The Cambourne to Cambridge Order

THE CAMBOURNE TO CAMBRIDGE ORDER

PROOF OF EVIDENCE

On behalf of Cambridgeshire County Council

Figure 1: Map of Internationally Designated Sites

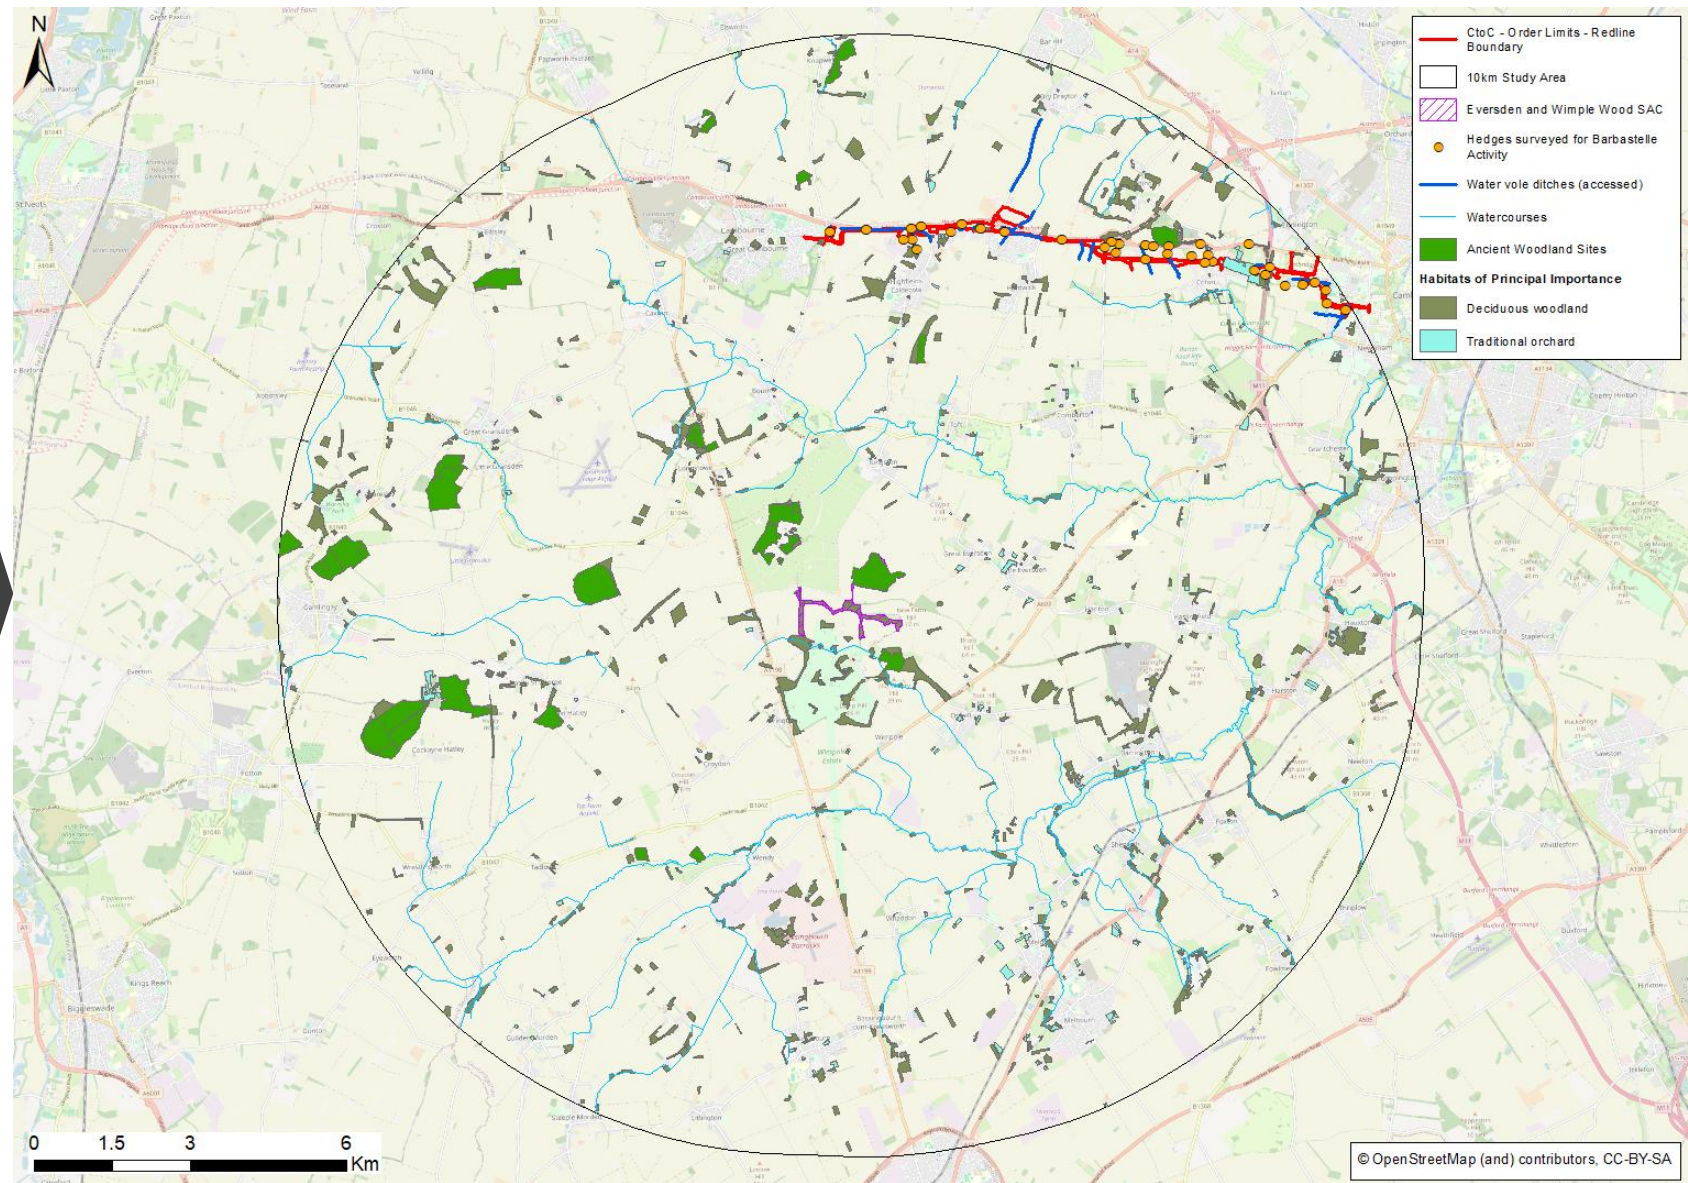
- *Coton Orchard has recently been designated as a County Wildlife Site (CWS) the map in Figure 5.2 of Appendix A of the Technical Report 5 – Ecology [C2C-11-TR05-00] should be updated.*

ISSUE	NATURAL ENGLAND'S POSITION	APPLICANTS POSITION	STATUS
1. Coton Orchard CWS	Coton Orchard has recently been designated as a County Wildlife Site (CWS) the map in Figure 5.2 of Appendix A of the Technical Report 5 – Ecology [C2C-11-TR05-00] should be updated.	The designation of the CWS is acknowledged and it is confirmed that this designation does not alter the assessment of effects on the barbastelle and extant bat population. [link back to HRA Coton comments]	AGREED

2.1.	GC acknowledges on behalf of the Applicant, that Coton Orchard is designated as a County Wildlife Site (CWS). While this was missing on Figure 5.2 of Appendix A, it was outlined elsewhere throughout Technical Report 5 of the ES.

BARBASTELLE HABITAT ASSESSMENT

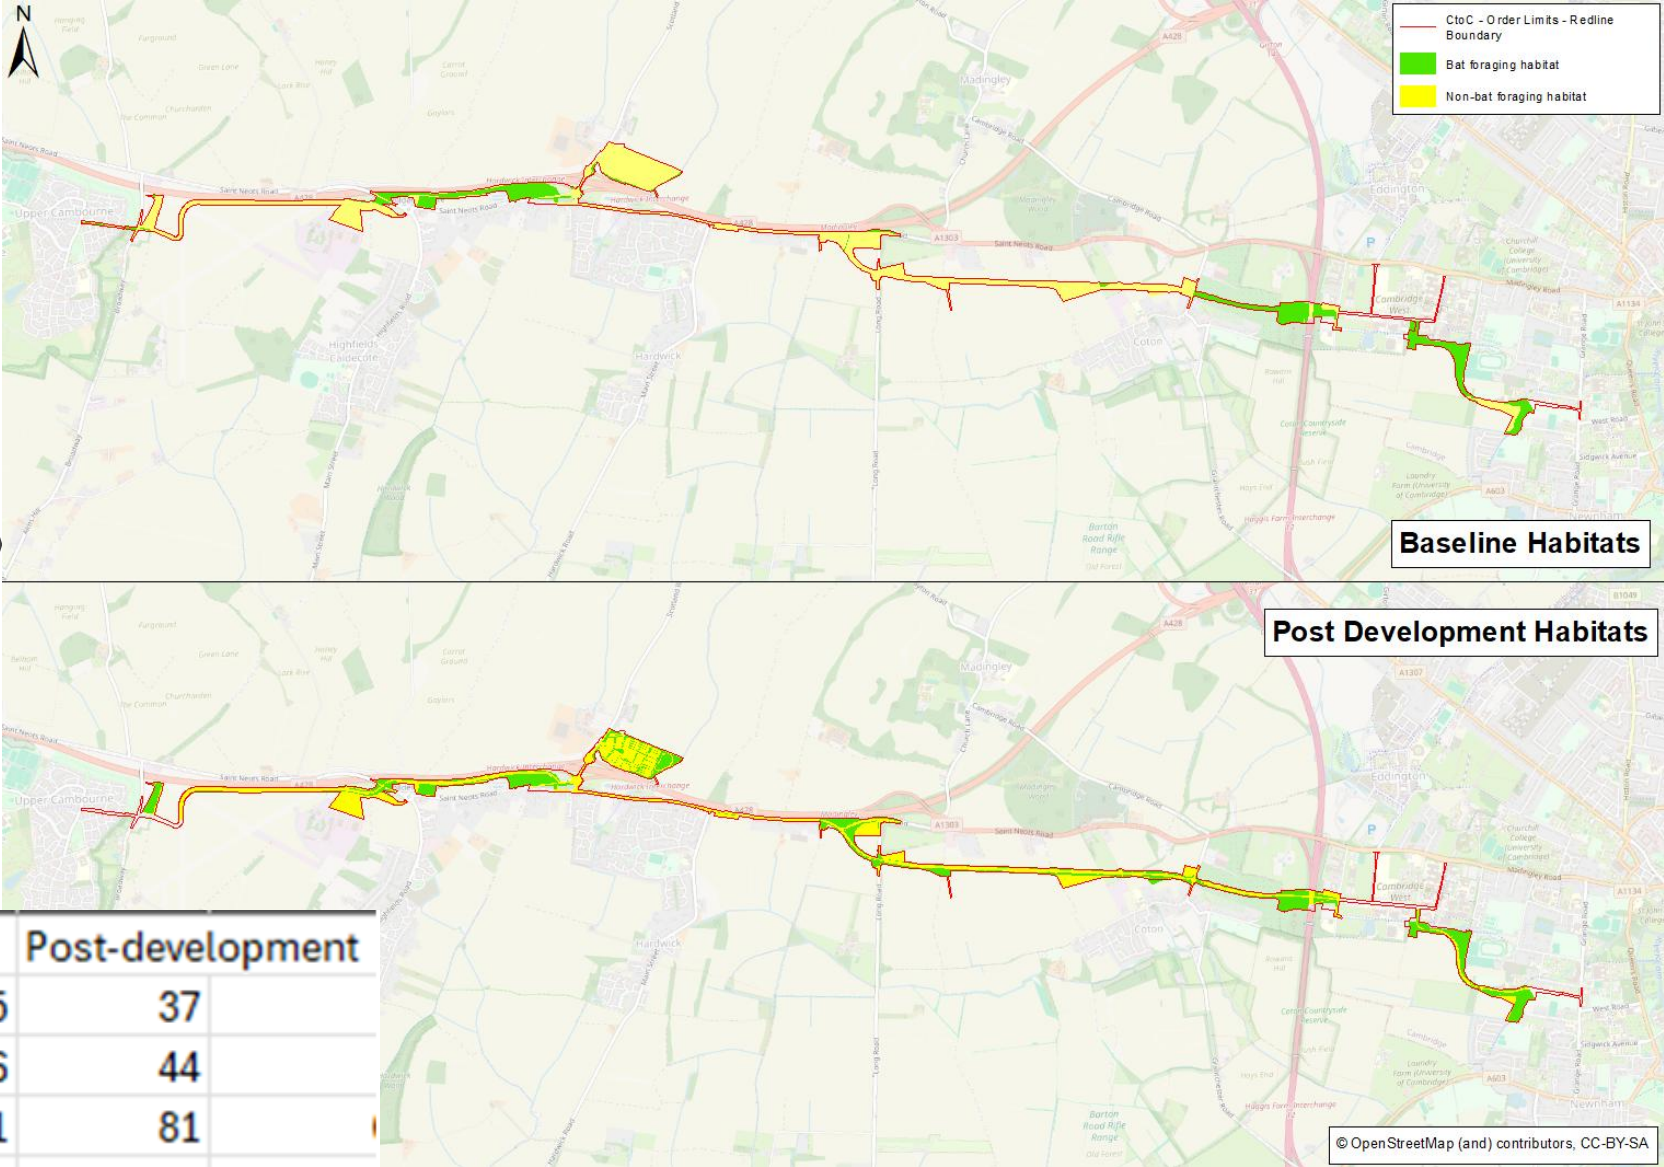
ISSUE	NATURAL ENGLAND'S POSITION	APPLICANTS POSITION	STATUS
2.	<p>Insufficient evidence providing certainty that there will be no adverse effects on the integrity of the Eversden and Wimpole Woods SAC and to support the statement made within the HRA, which states: <i>'the loss of these foraging areas are highly unlikely to have a significant effect on Barbastelle Bats given the availability of habitat in the wider landscape'</i>. Resulting in a further survey request for foraging and availability of habitat.</p>	<p>Robust evidence of foraging habitat available:</p> <ul style="list-style-type: none"> • within 20km & 10km of Eversden and Wimpole Bat SAC. • pre and post construction barbastelle foraging availability. <p>Shows there will be no net loss of bat foraging habitat as a result of the Scheme. In addition, there is wider existing habitat available within and beyond the scheme that is fully accessible to maintain the favourable conservation status of the bat population.</p>	TO BE DISCUSSED

- *The submitted Bat Activity Report [TR5.5] does not give enough consideration to foraging habitat, and the potentially most valuable foraging habitat impacted by the scheme (Coton Orchard) was not surveyed.'*
- *The potential impact of the scheme on ... micromoths should therefore be taken into account in order to assess potential impacts on barbastelles. An analysis of the larval and foodplants of the moths should be undertaken,*

Baseline	Post-development
Bat Foraging Habitat	25	37
Non-bat Foraging Habitat	56	44
	81	81

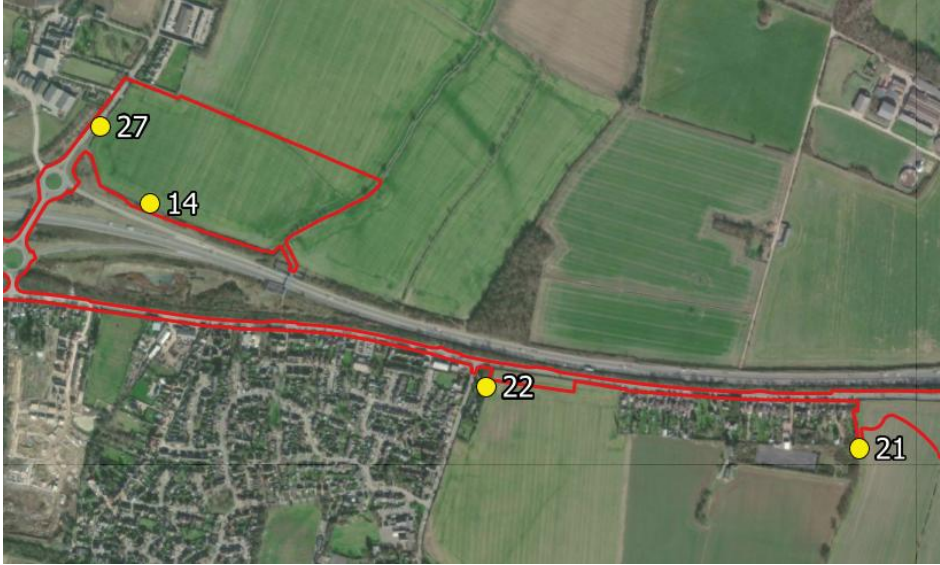
Natural England response following April 2025 meeting	Reference to paragraphs above where this concern is addressed and/or response where required.
<p>midnight, and which only had first registrations after midnight. As stated in part 3 of our representation, this would help to pinpoint the areas that should be prioritised for the highest quality mitigation measures.</p>	<p>full darkness. There was no evidence that bats were leaving their 'home woodland' before dark, and no evidence of them crossing below vehicle height.</p> <p>Analysis of our static data of 1151 Barbastelle bat registrations across all locations and the whole survey season shows that 80% (921 bat registrations) of all barbastelle calls were recorded over 1.5 hours after sunset.</p> <p>A total of 65 barbastelle bat registrations across all locations and the whole survey season (5.65% of all barbs recorded) was recorded within the first hour post sunset.</p> <p>Of the 5.65% earlier calls, the spread of these across the survey season recorded peaks in April (2.26% of all barbastelle passes recorded), July (1.56% of all barbastelle passes recorded) and October (1.04% of all barbastelle passes recorded).</p> <p>Of the 5.65% of earlier calls in regard to location, a peak of these earlier passes (1.65% of all barbastelle passes recorded) was recorded at static detector location 22. This static detector was located south of the A428 on the edge of a well vegetated garden. A small woodland block is located immediately north across the A428, and the static detector location is approximately 2.2km west of Madingley Wood SSSI. The bus route is on line along St Neots Road at this location.</p>

Post Meeting Note: A variance crossing heights were noted across the A1303. The 20m+ observation was correct the time of the Natural England liaison

1A
 Crossing point 6 – The ditch line southwest of Madingley
 Wood;

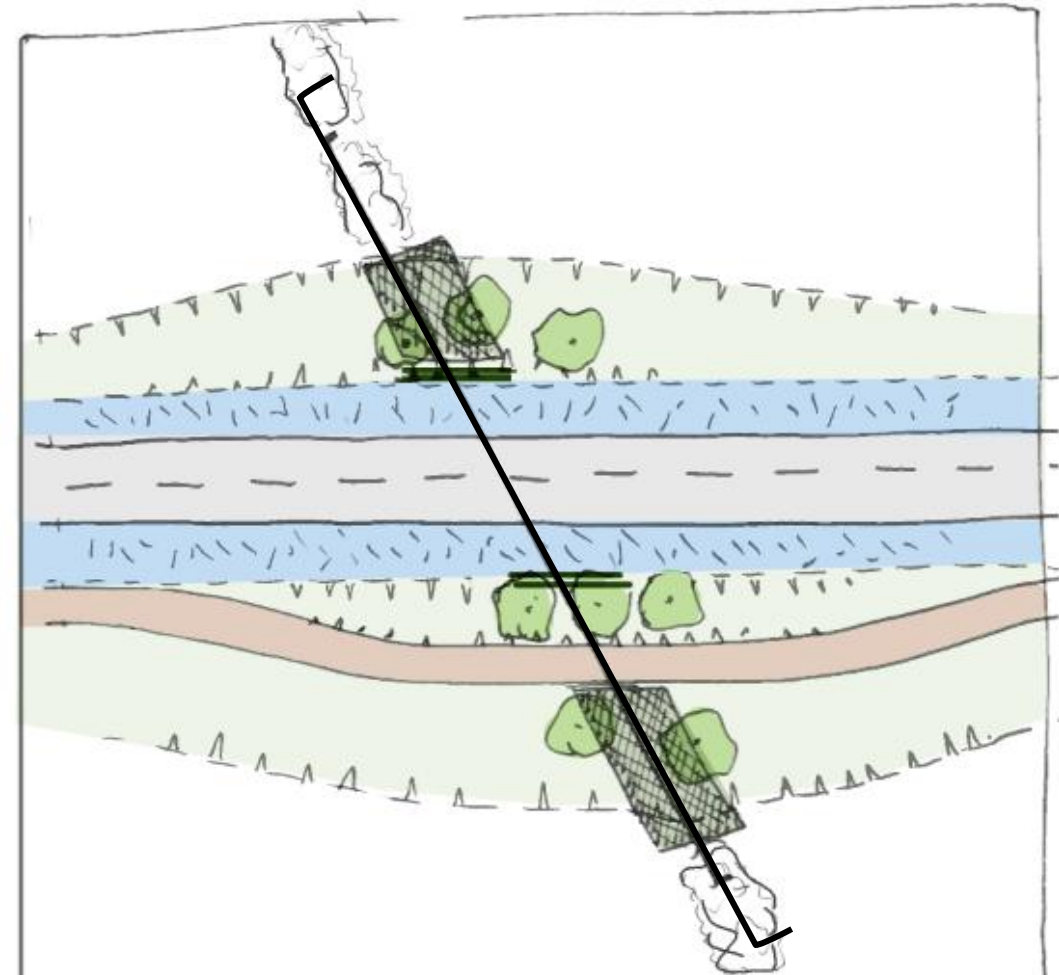
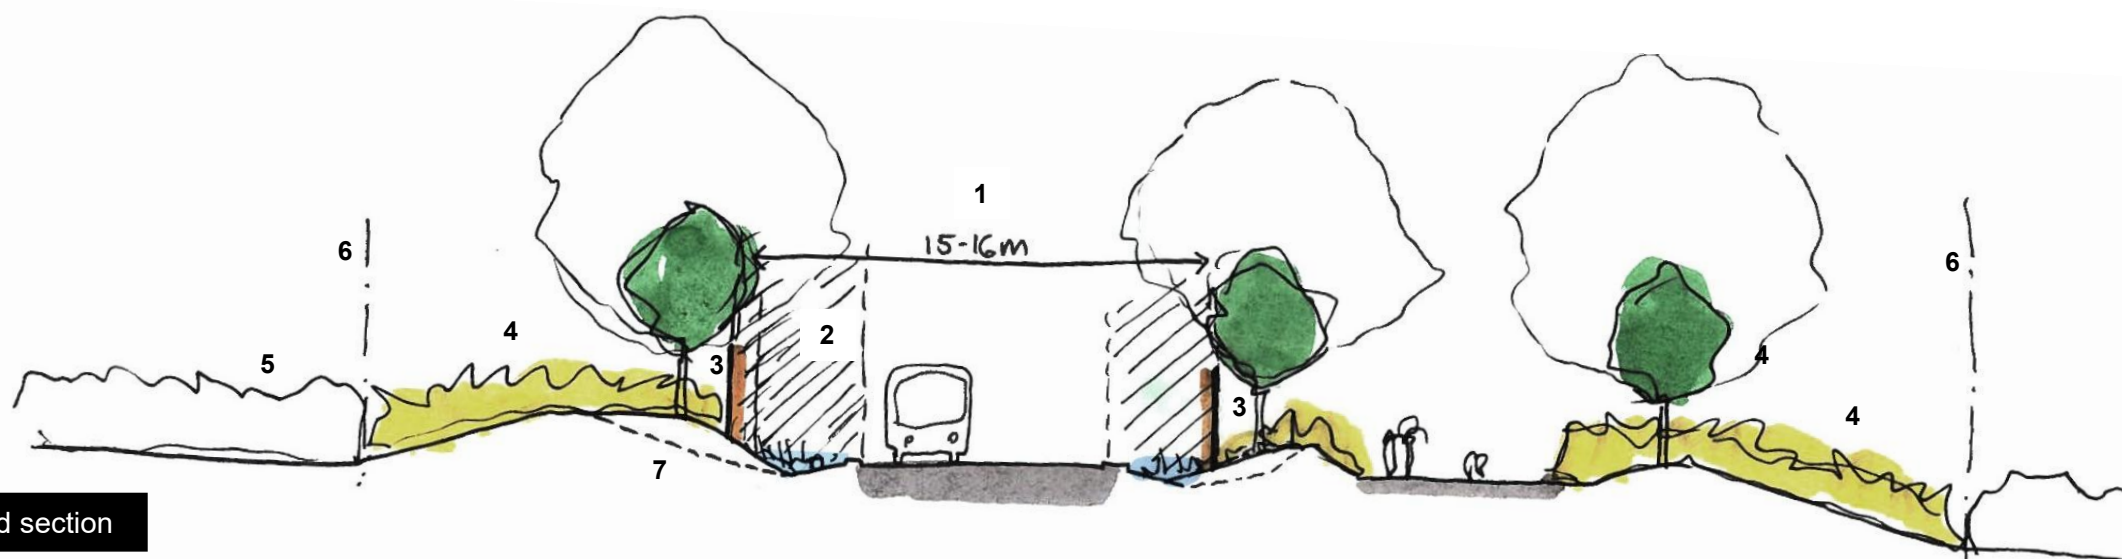
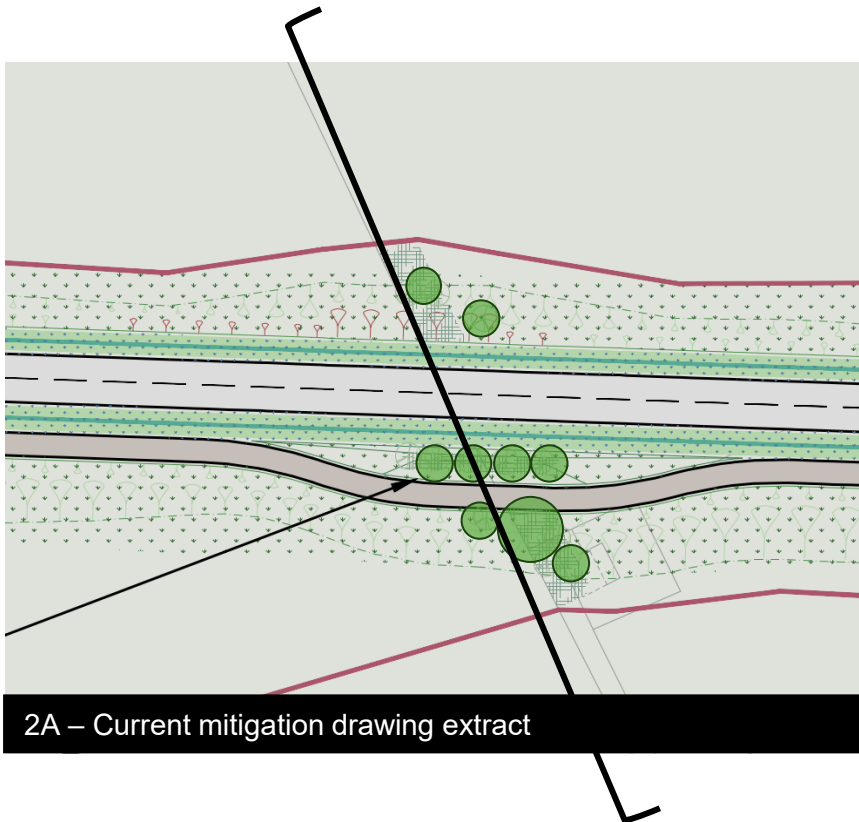
- *The gap between the canopy heights either side of the new road should be less than 20m to encourage bats to maintain their flight height over the road'. We strongly advise that 20m is much too wide for an effective crossing point, and request that the exact specifications and width of each crossing point be provided at this stage within a definitive plan. The gap between canopies should not be any wider than a standard two-lane road, preferably less – we believe this would be narrower than 7m, depending on the bus width.*

- *We strongly advise that 20m is much too wide for an effective crossing point, and request that the exact specifications and width of each crossing point be provided at this stage within a definitive plan.*

1. Mounds locally reshaped to minimise dim between trees
2. Vehicle visibility spays (to be kept clear)
3. Willow waffle fence + dense hedgerow (or greened fencing adjacent to private owned land)
4. Forgeable vegetation
5. Existing hedgerow
6. Red line boundary
7. Dashed line – current TWA topography
